From: Mark Simmons <[REDACTED]>
Sent: 31 July 2026 14:44
To: Vicki Wood [REDACTED]
Subject: 2no. DOC's re: 32 Church Street, Baldock, Hertfordshire, SG7 5AF

26/01738/DOC - Details of Condition : Details reserved by Condition 2: (Materials) of Listed Building Consent 25/03083/LBC granted 02.02.2026

26/01824/DOC - Details of Condition : Details reserved by Condition 3: (Joinery details) of Listed Building Consent 25/03083/LBC granted 02.02.2026

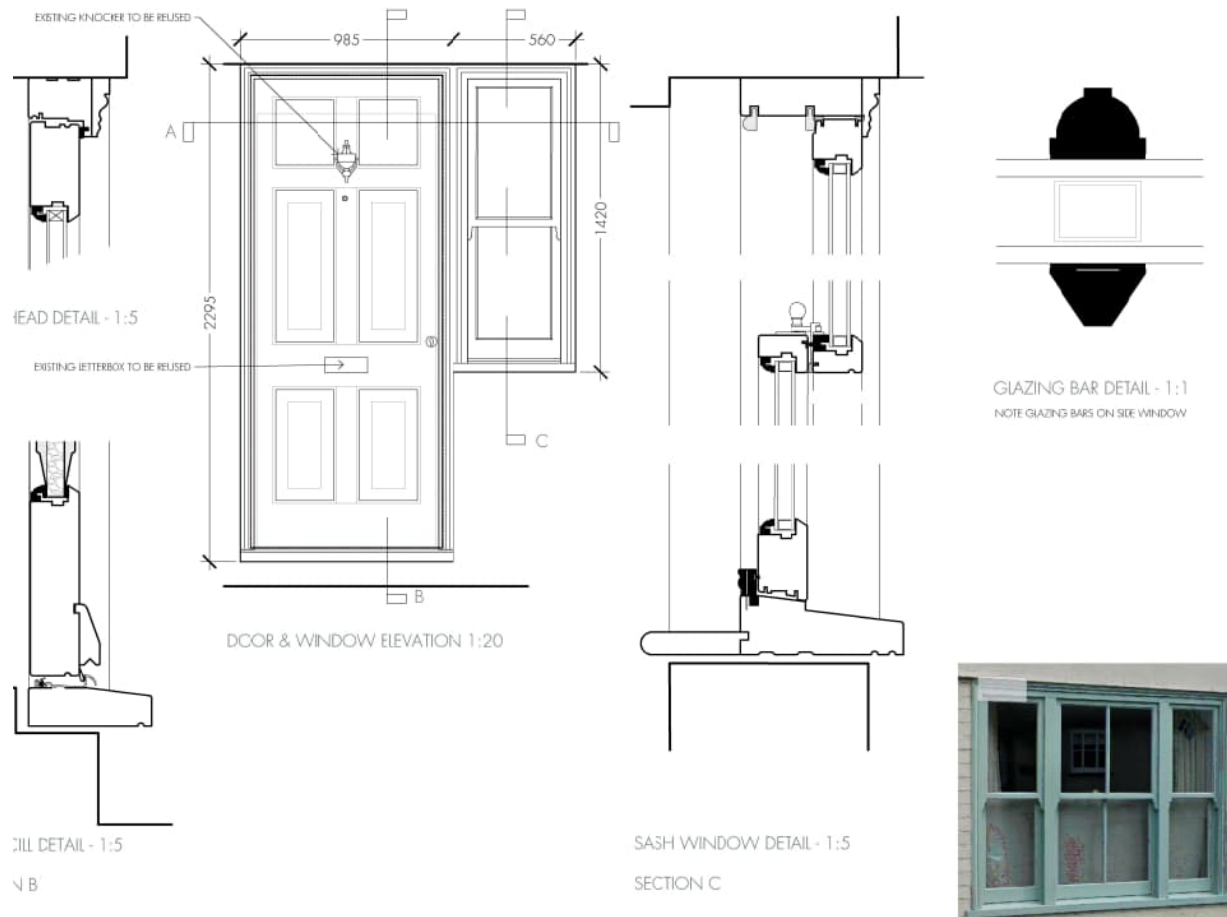
The two front windows implemented circa 2007 appear to have narrow double-glazing as seen below left (maybe 4:6:4 or 4:8:4), whereas the glazing detail on drawing no.BHI-550 Rev B appears to show a wider glazing system with applied bars. If what has been submitted is wider than the existing then, although, the front window has no glazing bar, I would expect the detailing to the side window to be similar or indeed better than that implemented in 2007. I am not convinced that would be the case. Await clarification on existing and proposed glazing systems.
